STAFF RECOMMENDED REVISIONS TO THE 9/3/08 NBG REGULATING PLAN

City Staff recommends the following revisions be made to the 9/3/08 Draft NBG Regulating Plan, which was presented to Planning Commission on Sept. 9, 2008. These amendments are recommended to add clarification to the standards.

Figure 3-12 : North Burnet / Gateway (NBG) Zoning District
Collector Street Plan

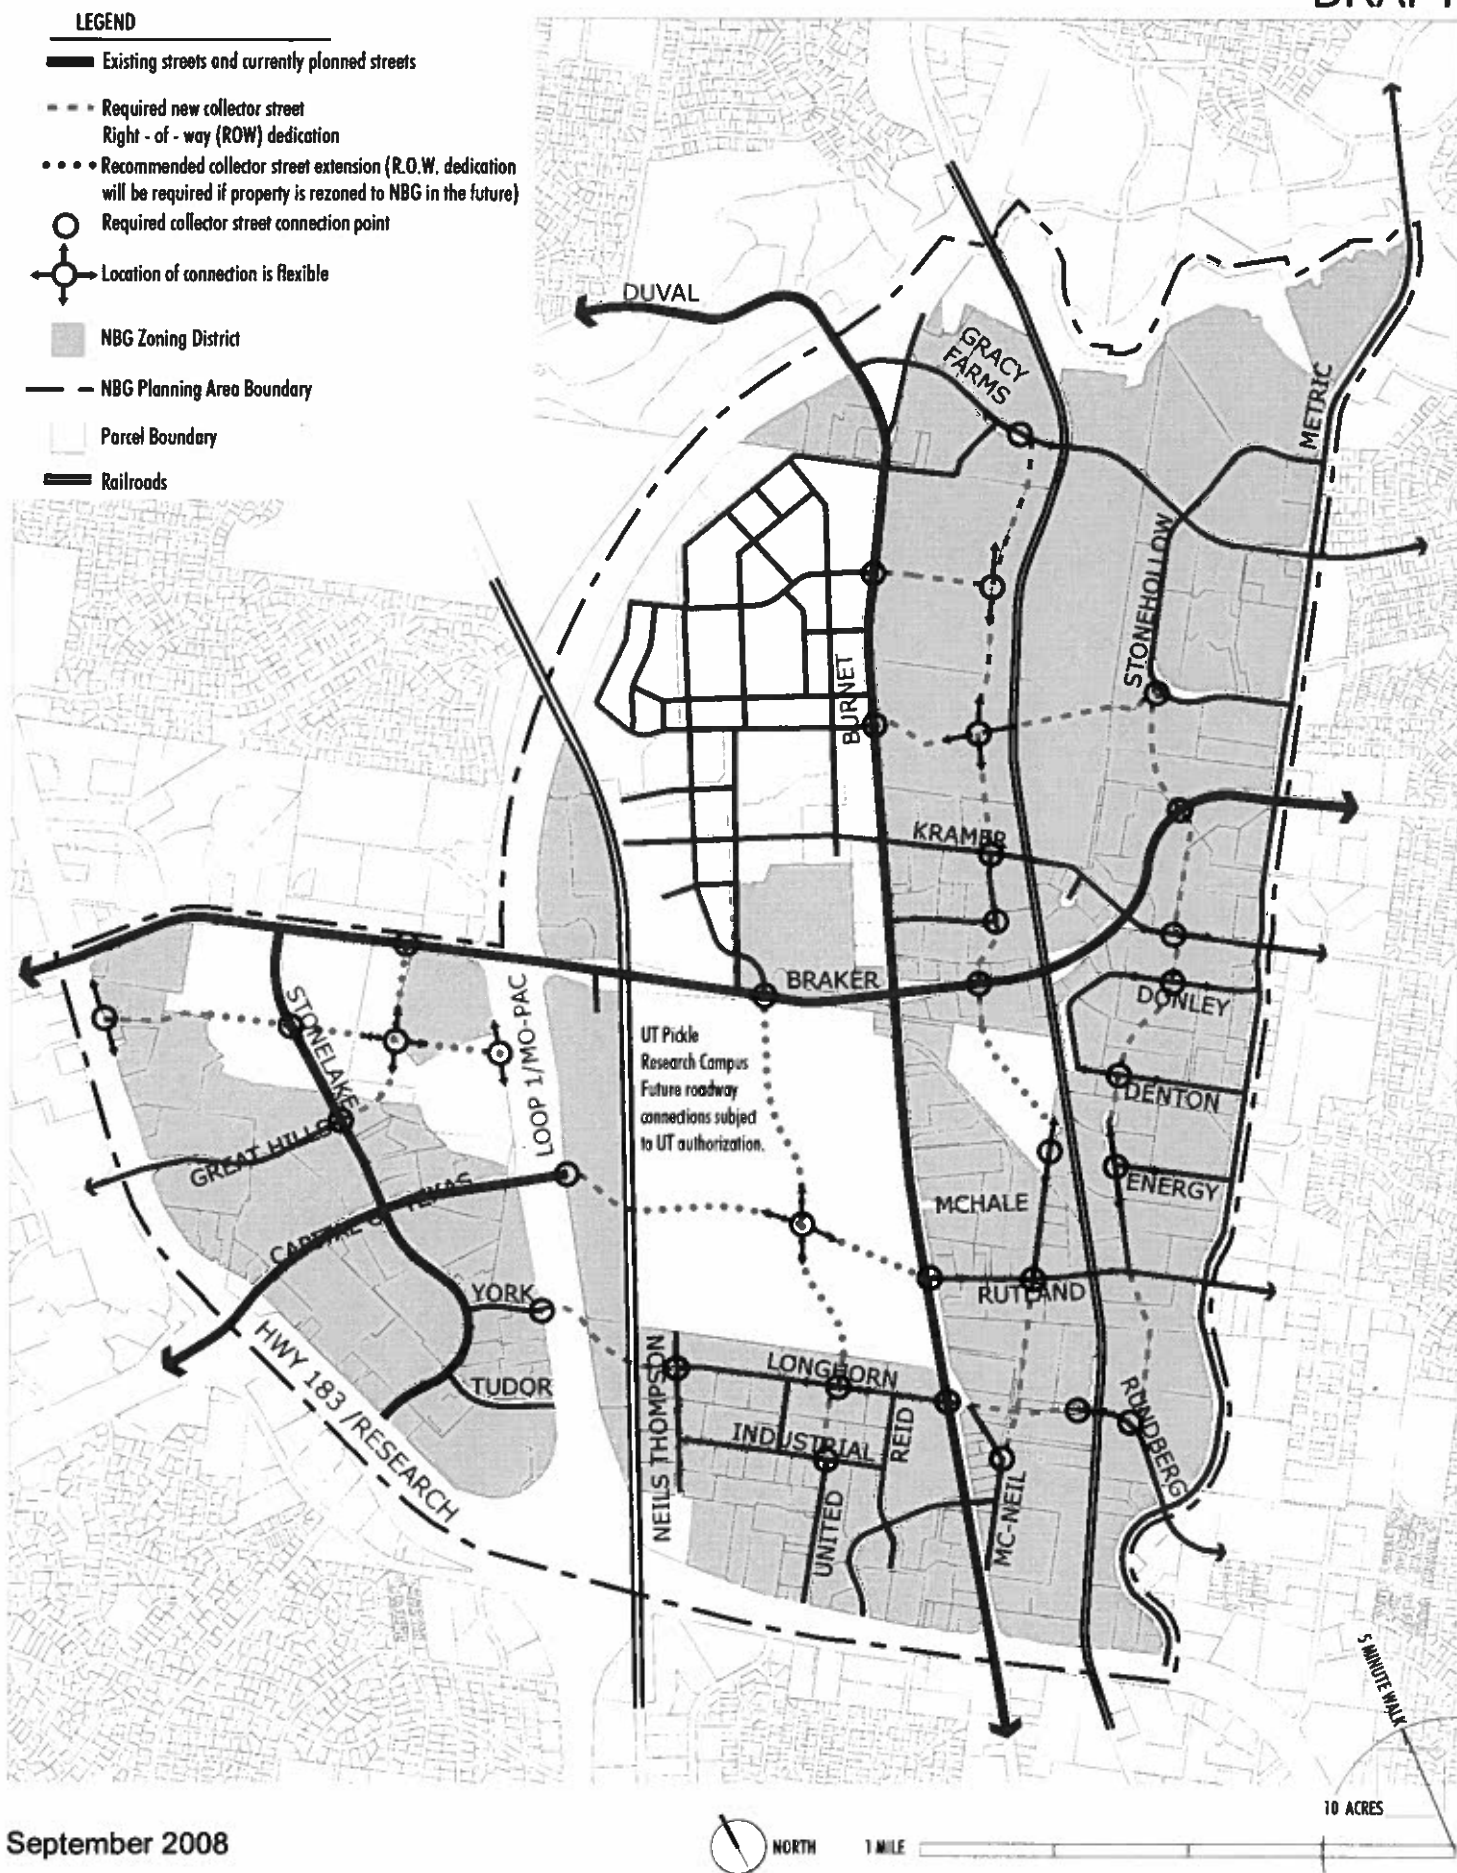
Recommendation: Revise Figure 3-12 (NBG Collector Street Plan) to recognize that future roadway connections on the University of Texas Pickle Research Campus are subject to UT authorization. (See attached Revised Figure 3-12).

Appendix A: North Burnet / Gateway (NBG) Zoning District Collector Street Cross Section Identification Plan

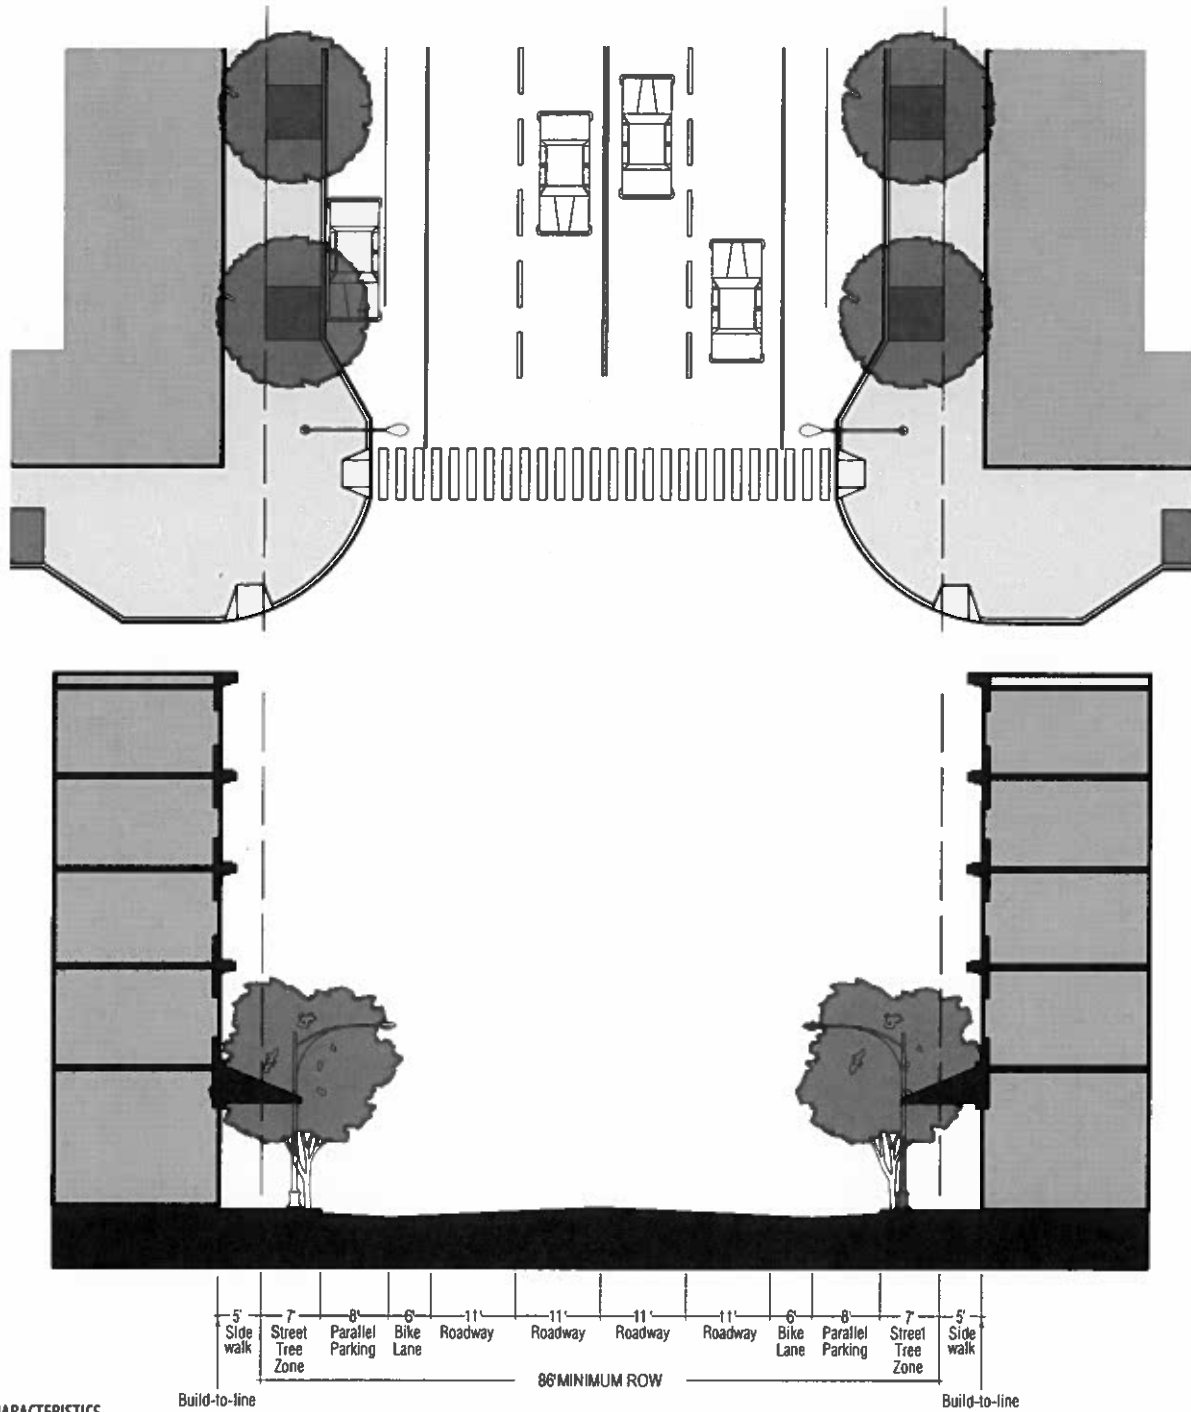
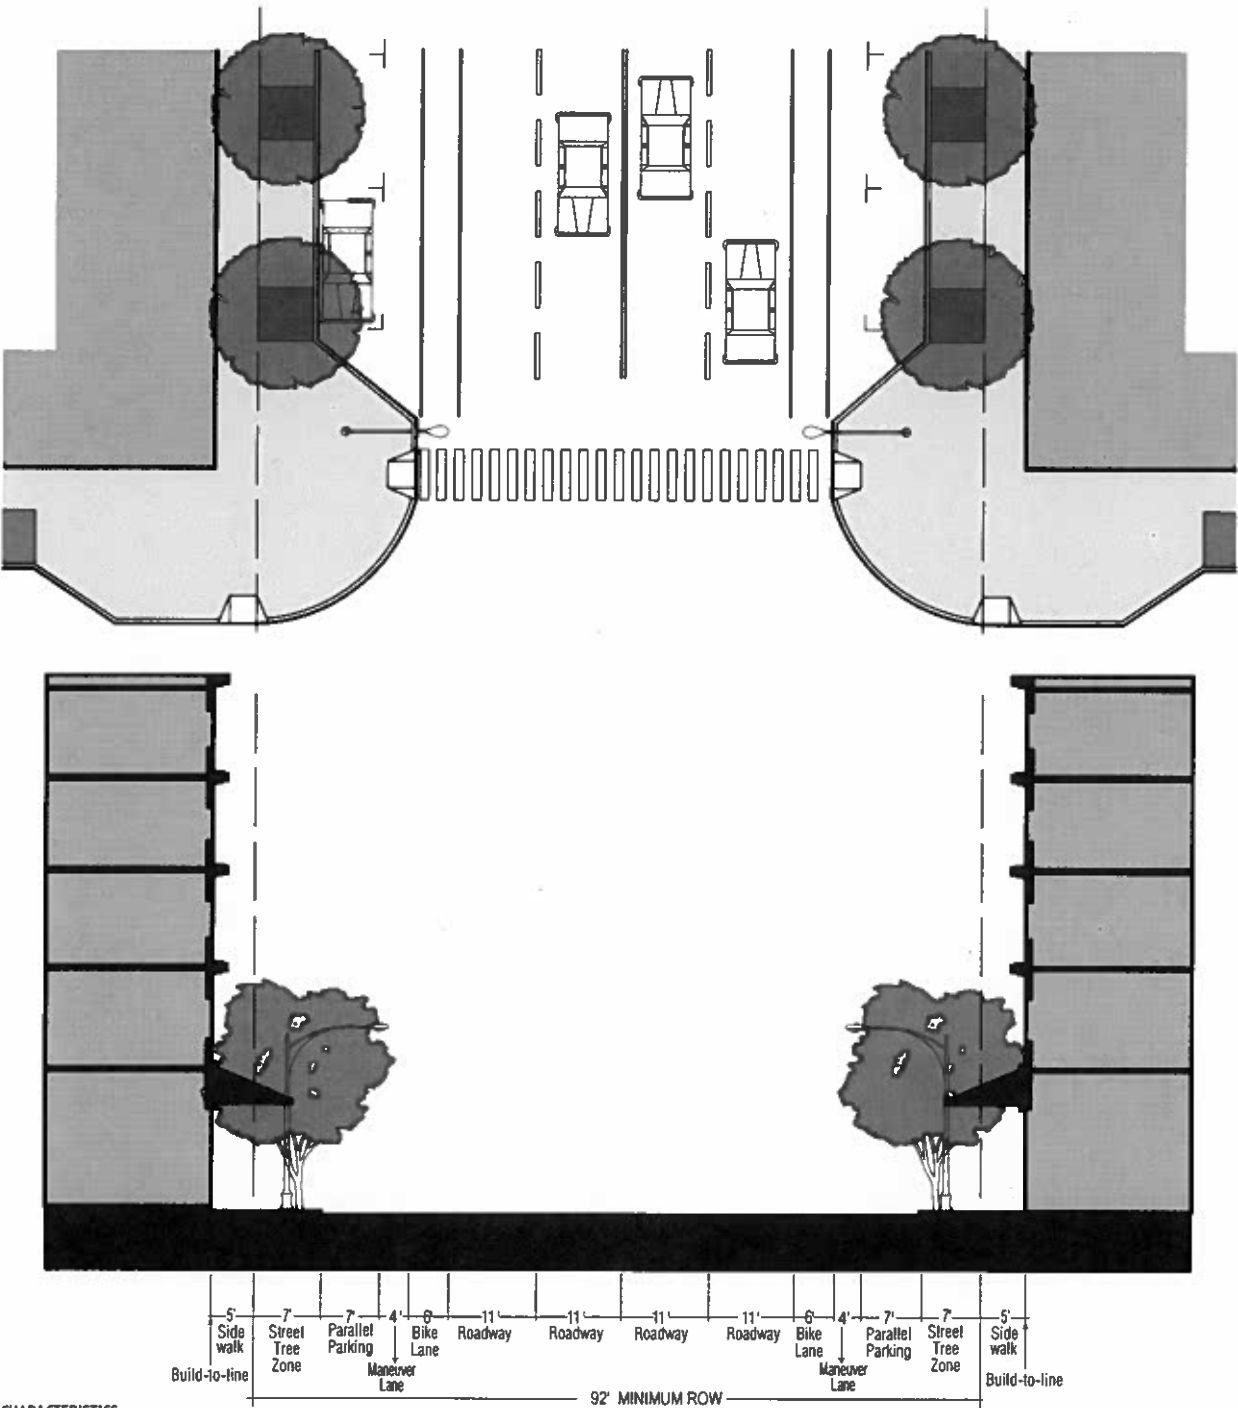
Recommendation: Revise the Primary Collector Street cross-sections options in Appendix A to reflect (30 ~~35~~ M.P.H. or less) and (Greater than 30 ~~35~~ M.P.H.) and include a Collector Street Cross-Section Identification Plan. – See revised figures attached.
